ADDENDUM NO. 03

Date: 09.19.2025

Project: Sheridan HS and MS School Renovation Project

The Hagerman, Inc portion of this Addendum consists of the following information:

DRAWING NUMBER S201 PROJECT NUMBER 2024037

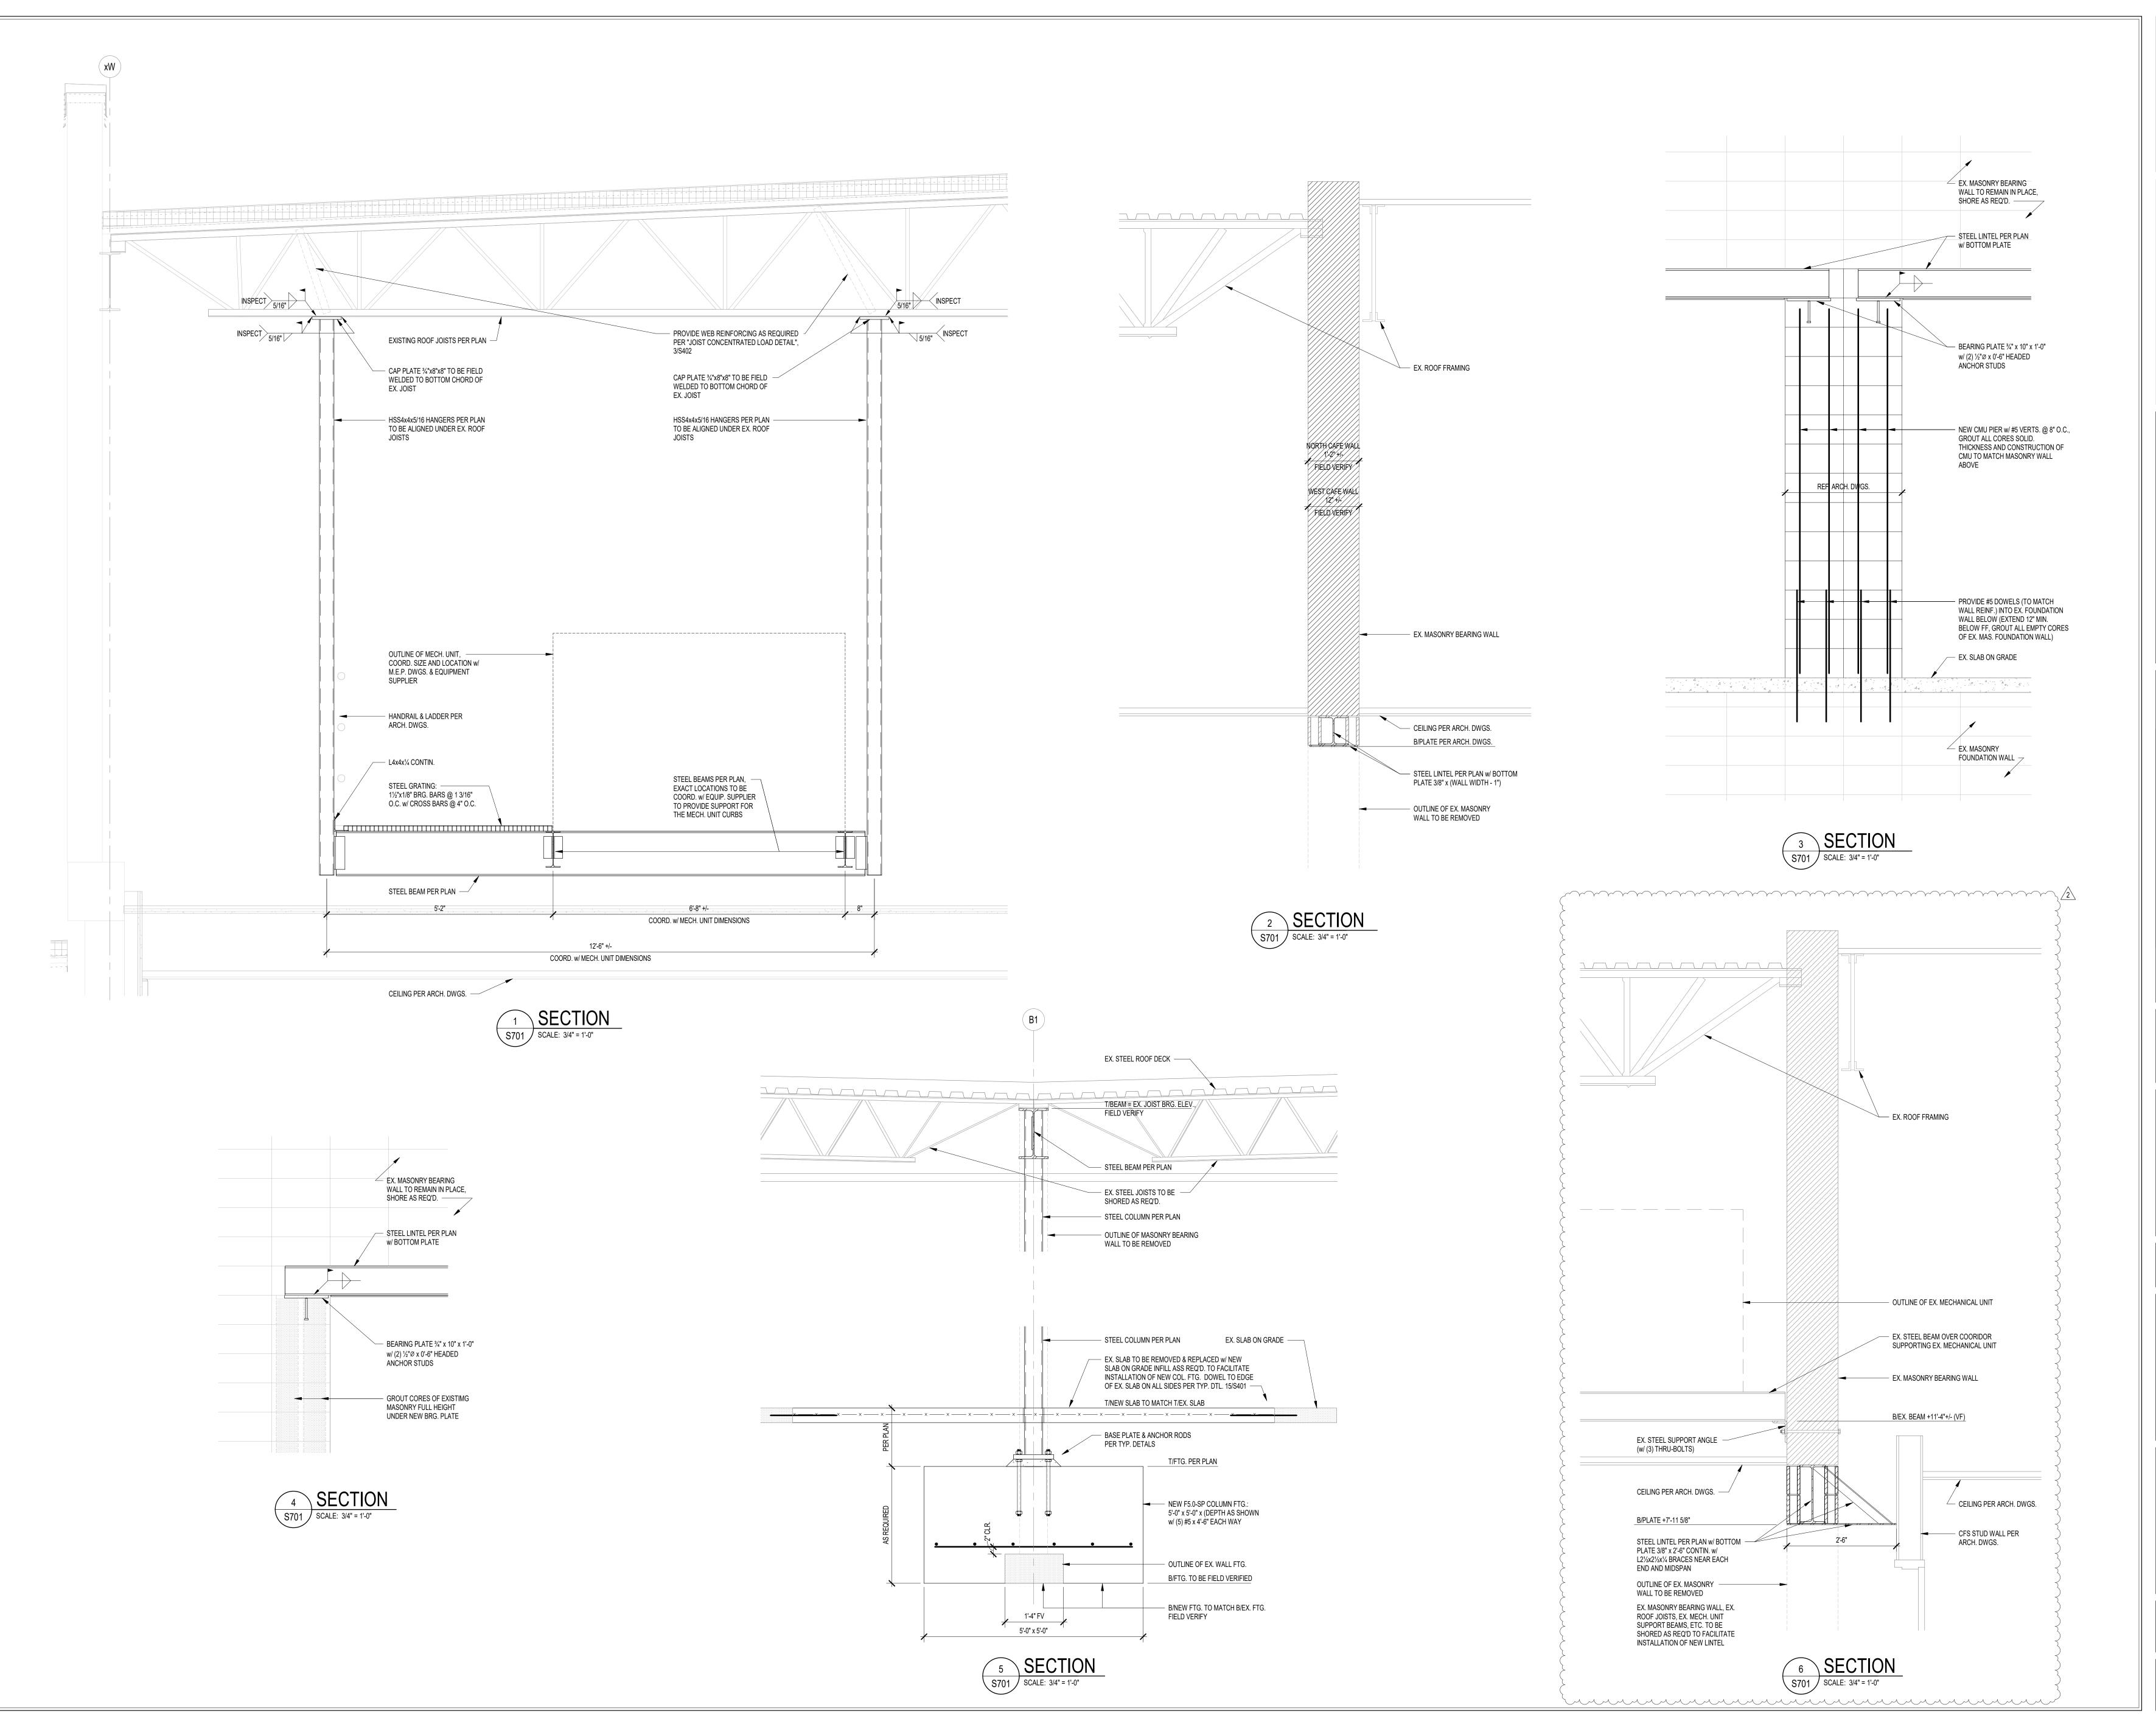
- 8. Bid Item #06 Drywall Contractor shall furnish and install acoustic joint sealants per updated spec section 07 92 00, 2.06, A.2 and drawings.
- 9. Bid Item #03 Steel Contractor shall review the Drawing S201 and furnish the steel per the revised detail 6 on and S701 as part of lintel and Bid Item #02 Masonry Contractor to install.

- 3.1 <u>S201 ROOF FRAMING PLANS UNITS A & D</u>
 - A. Add section 6/S701.
- 3.2 S701 FRAMING SECTIONS AND DETAILS
 - A. Add section 6/S701.

DRAWING NUMBER **AD201A** PROJECT NUMBER 2024037

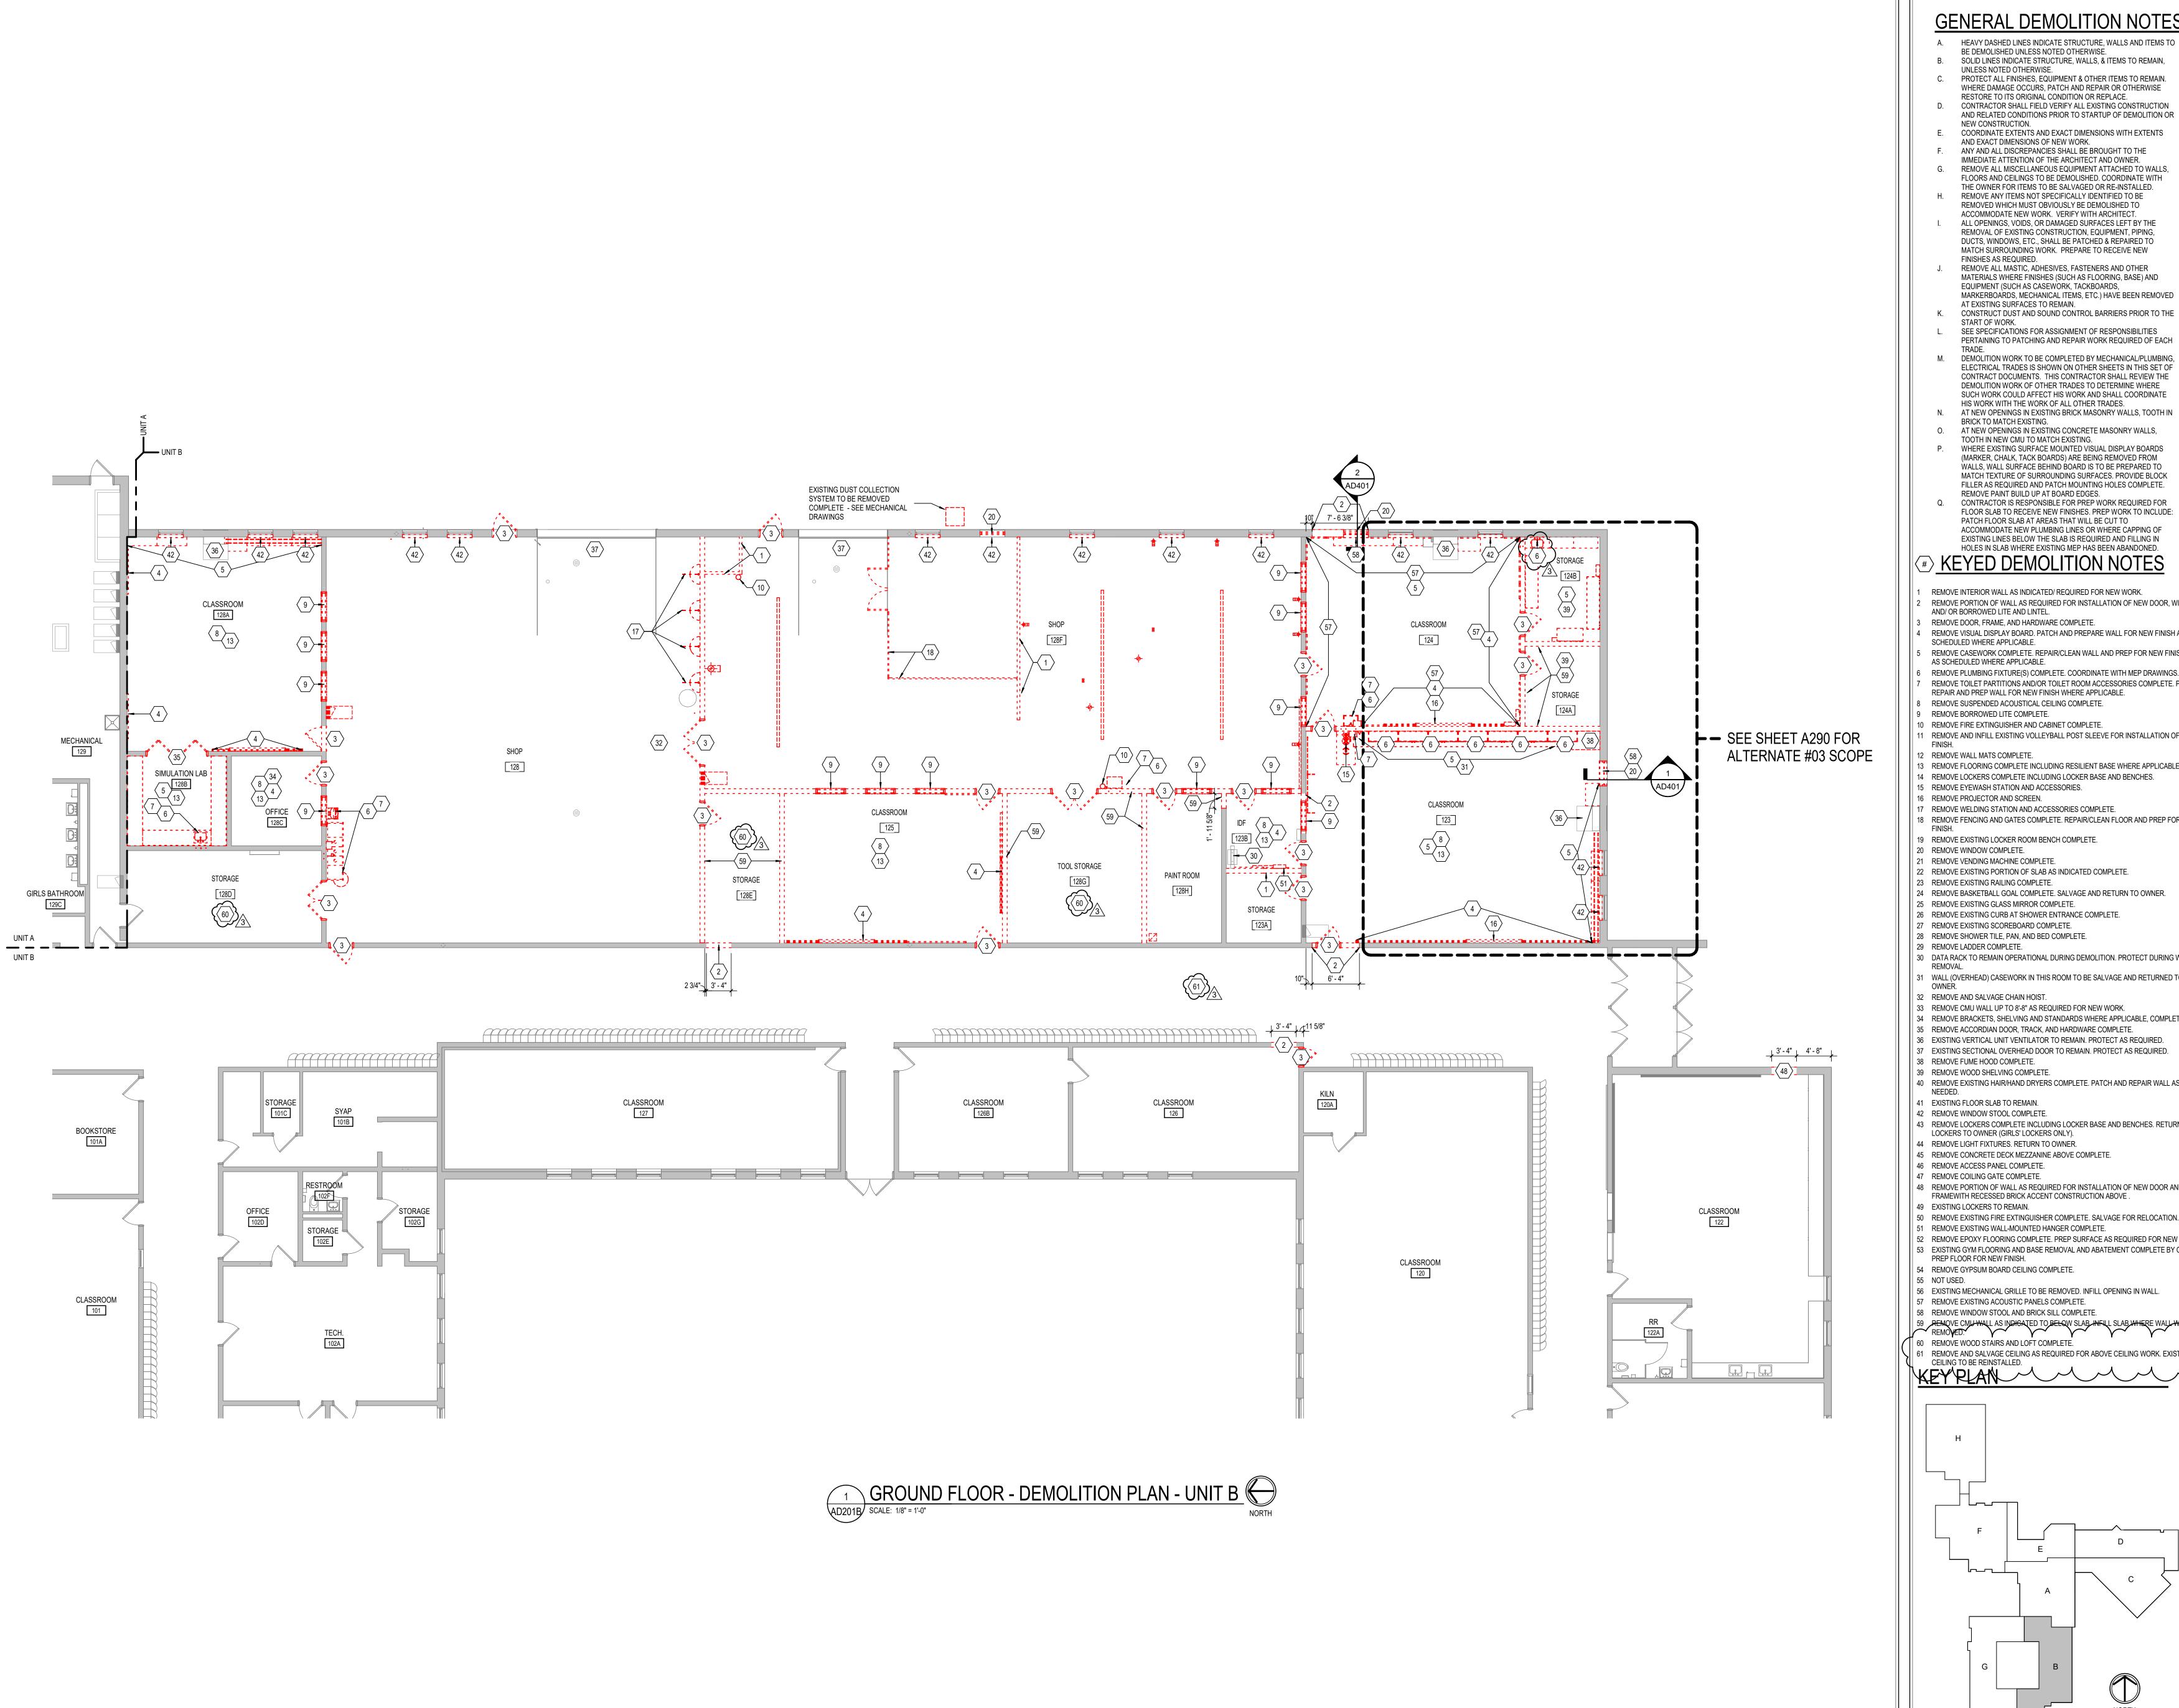
- 10.Bid Item #01 General Trades Contractor shall be responsible for removing the wood stairs and storage lofts per the added Keyed Demolition Note 60 on Drawings AD201A, AD201B, and AD201D.

- 11.Bid Item #06 Drywall Contractor shall be responsible for added Keyed Demolition Note 61 on Drawing AD201A, AD201B, and AD201D. Refer to the MEP Drawings for above ceiling scope.

- 12.Bid Item #02 Masonry Contractor shall be responsible for block infill per revised Keyed Demolition note 56 on Drawings AD201A, AD201B, and AD201D.

- 3.3 <u>AD201A GROUND FLOOR DEMOLITION PLAN UNIT A</u>
 - A. Revise wall demo dimensions for new opening to Mechanical 300.
- 3.4 <u>AD201B GROUND FLOOR DEMOLITION PLAN UNIT B</u>
 - A. Add note 6 to Storage 124B.
 - B. Add note 60 to Storage 128D, Storage 128E, and Tool Storage 128G.
